APPENDIX 10

Structural engineers report (Mott MacDonald)

RE: 11-13 Randle Street, Surry Hills – Structural Report

FIGURE 1: BUILDING SECTION SHOWING TWO STOREY ADDITION ABOVE LEVEL 5

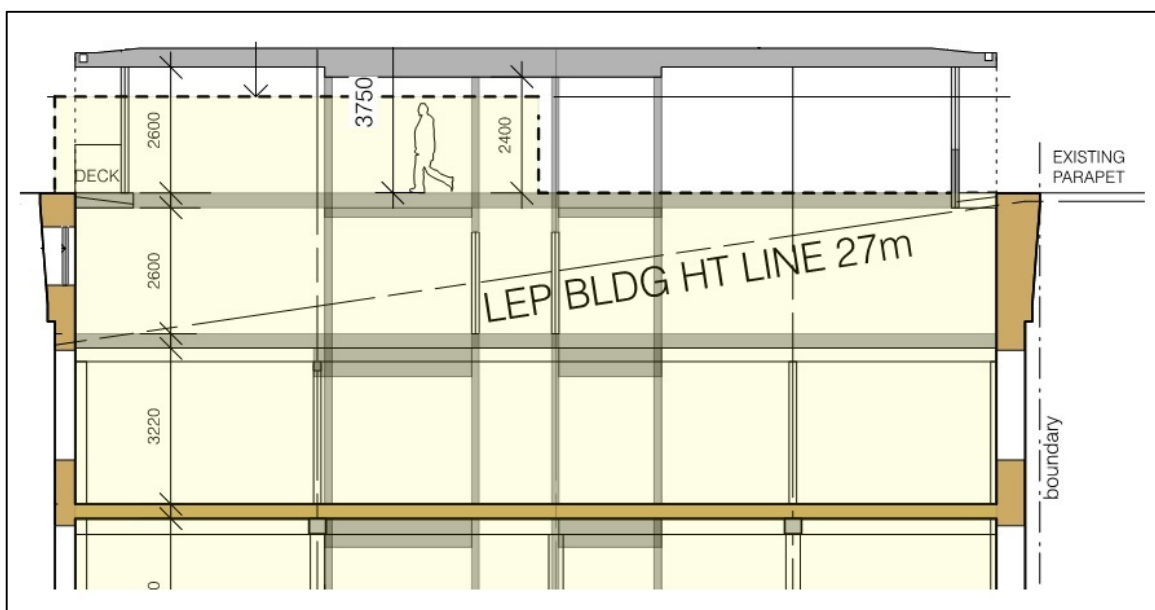
assume therefore that no additional (false) floor structure will be required at L5. Loads associated with the new floors have been determined to be as follows:

- L6 and L7 Live loads (per level): 2.0kPa
- L6 and L7 floor structure weight (per level): 0.6kPa
- Superimposed dead loads L6 and L7 and roof (per level): 1.0kPa
- New roof structure weight: 0.5kPa
- Roof live load: 0.25kPa

- Design column axial load at L1: 890kN
- Design column axial load at ground floor: 1040kN
- Design column axial load at basement: 1190kN

Based on the column capacities advised in section 3.0 we confirm the columns have sufficient axial capacity to carry the proposed two storey addition.

Geotechnical investigation is required to confirm the dimensions of existing footings and the bearing capacity of founding material prior to an assessment of the adequacy of footings to carry the proposed loads.

Based on the existing performance of the building it appears reasonably likely that the existing footings will have sufficient capacity to carry the proposed loads. Geotechnical investigation will be required to confirm this.

FIGURE 2: PARTIAL REMOVAL OF THE GROUND FLOOR STRUCTURE

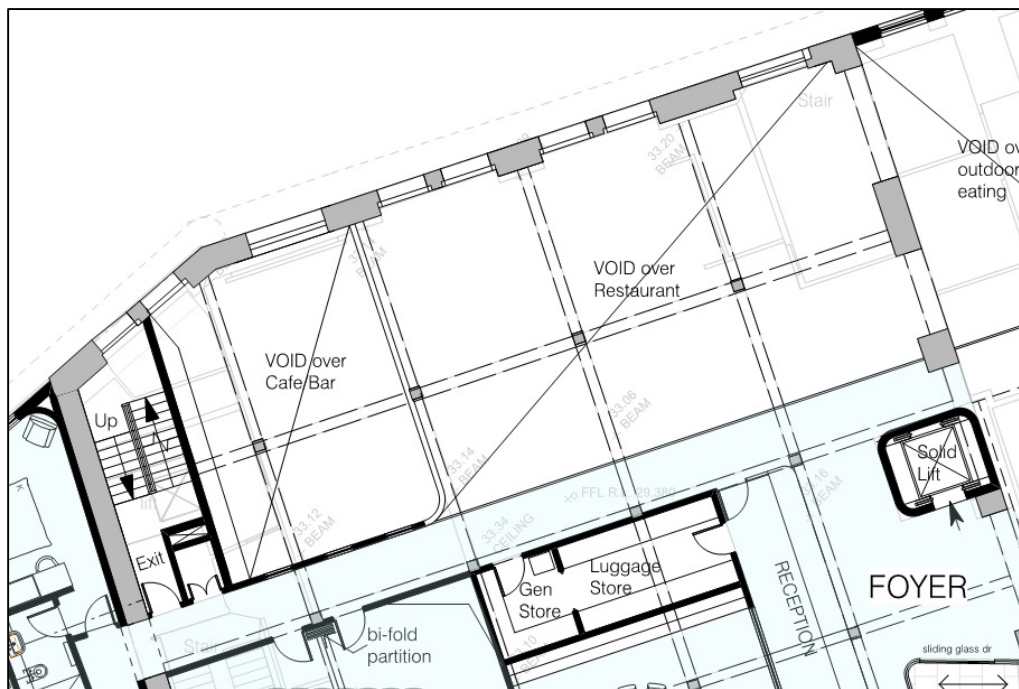
Removal of the ground floor structure to the extent shown on the architect's drawing 1519-DD06 is possible with the following restrictions:

- Retention of the existing beams in the east-west direction and installation of new bracing beams in the north-south direction are required at each column at the ground floor to provide lateral bracing to the columns, which would previously been provided by the joist and floorboard diaphragm. The new bracing beams shall be connected to a sufficiently robust structure (masonry walls or the remaining floor).
- Some timber or steel trimmers may be required to support joists where half bays are removed.

FIGURE 3: REMOVAL OF NORTH AND SOUTH PERIMETER WALLS

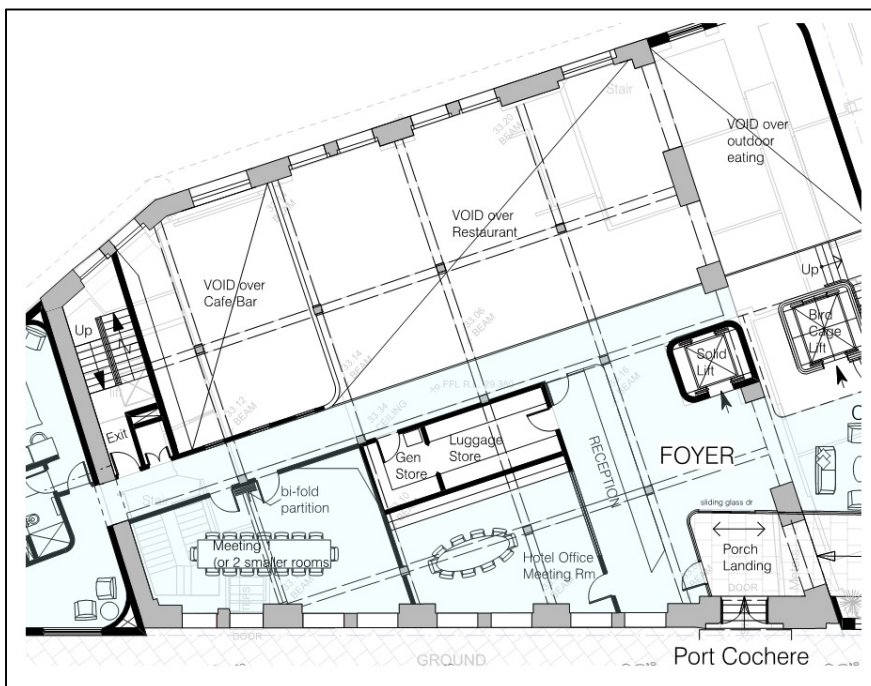
Large openings are proposed through the north and south perimeter walls at all levels to provide a continuous central corridor through the building and for accessing the adjacent buildings. To enable the creation of these openings the masonry above will need to be supported on a new lintel. This is likely to consist of several prestressed concrete lintels stacked across the width of the wall.

At the ground floor the north perimeter wall is shown to be punctured by several large openings, leaving only occasional masonry piers. As this wall is currently a major lateral force resisting element of the building, alternative means of resisting such forces will be required. It is expected that the “solid lift” shown on the line of this wall will act in the new development as a major lateral force resisting element, and will need to be designed as such (see section 7.0 Seismic Strengthening below for details).
